FINAL ENVIRONMENTAL IMPACT REPORT FOR THE

Cargill Mixed Sea Salts Processing and Brine Discharge Project

SCH No. 2022050436

June 2023

Figure 2-8h MSS Brine Transport Pipeline – Map 8

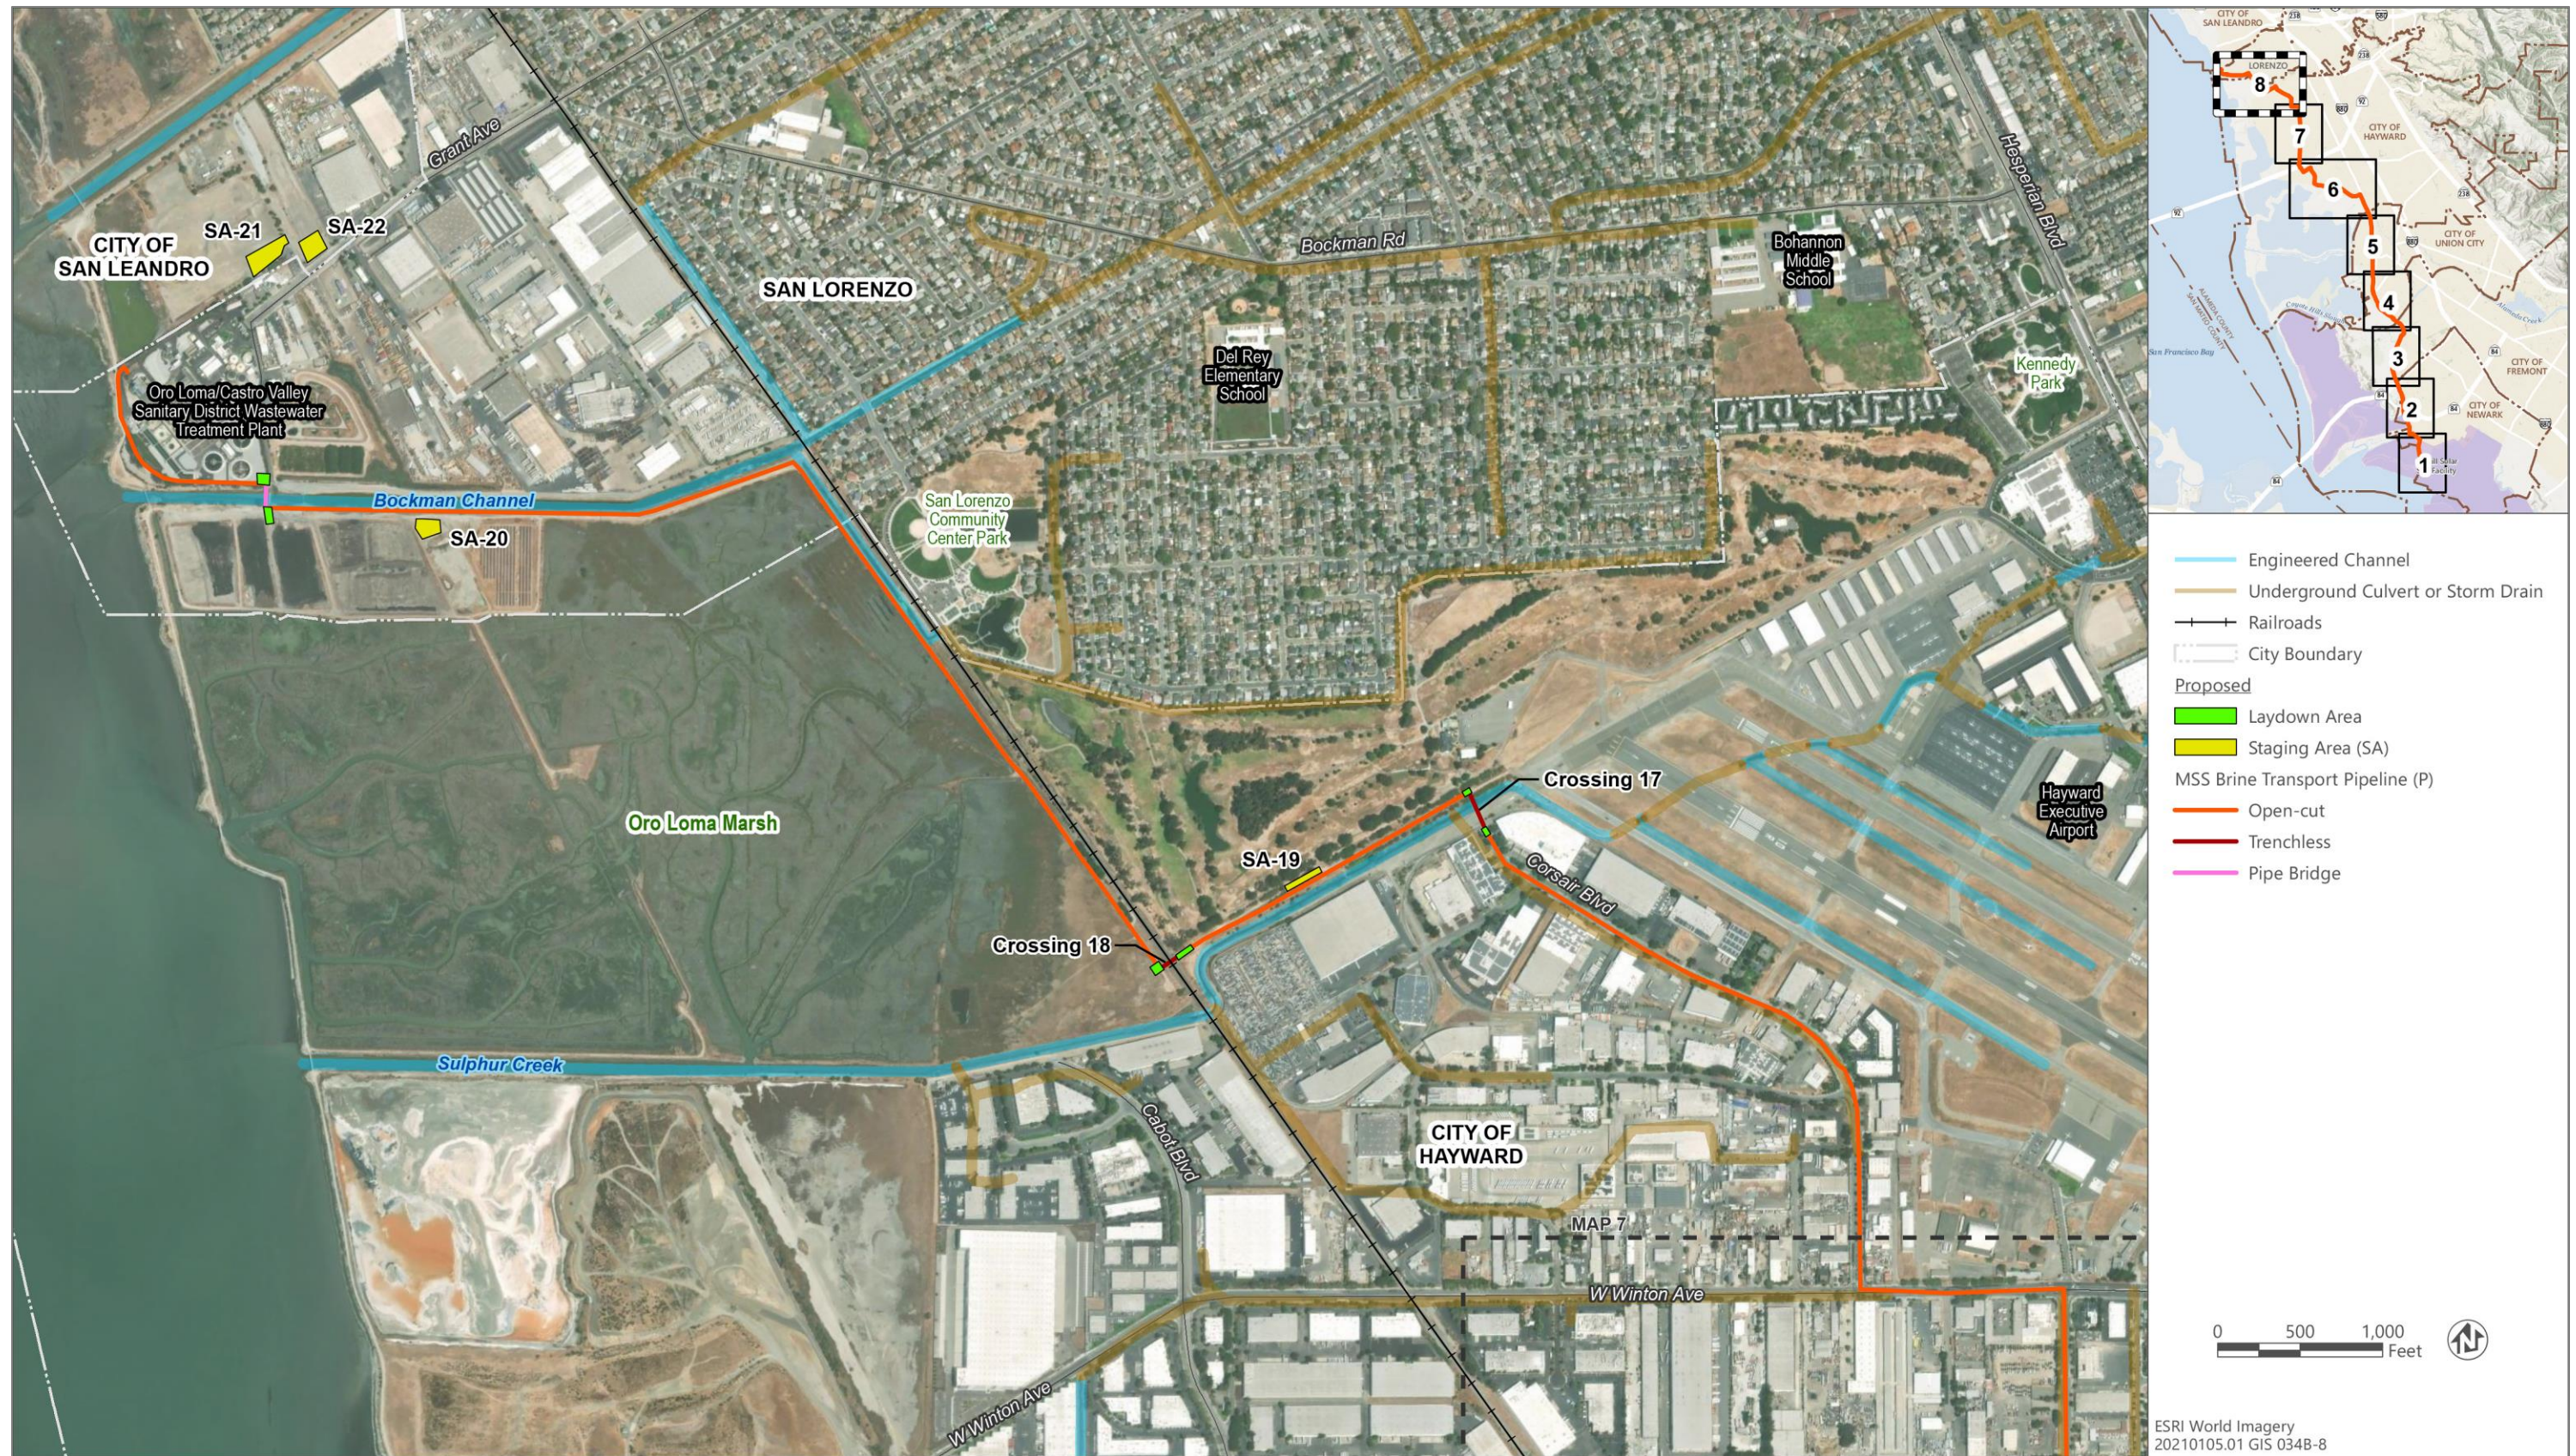
- 9) Between Crossing 20 and Crossing 21 on Figure 2-8h, the brine transport pipeline traverses around the perimeter of the Oro Loma Marsh. Please confirm there is adequate existing vehicular access to perform the visual inspections of the brine transport pipeline for this segment.
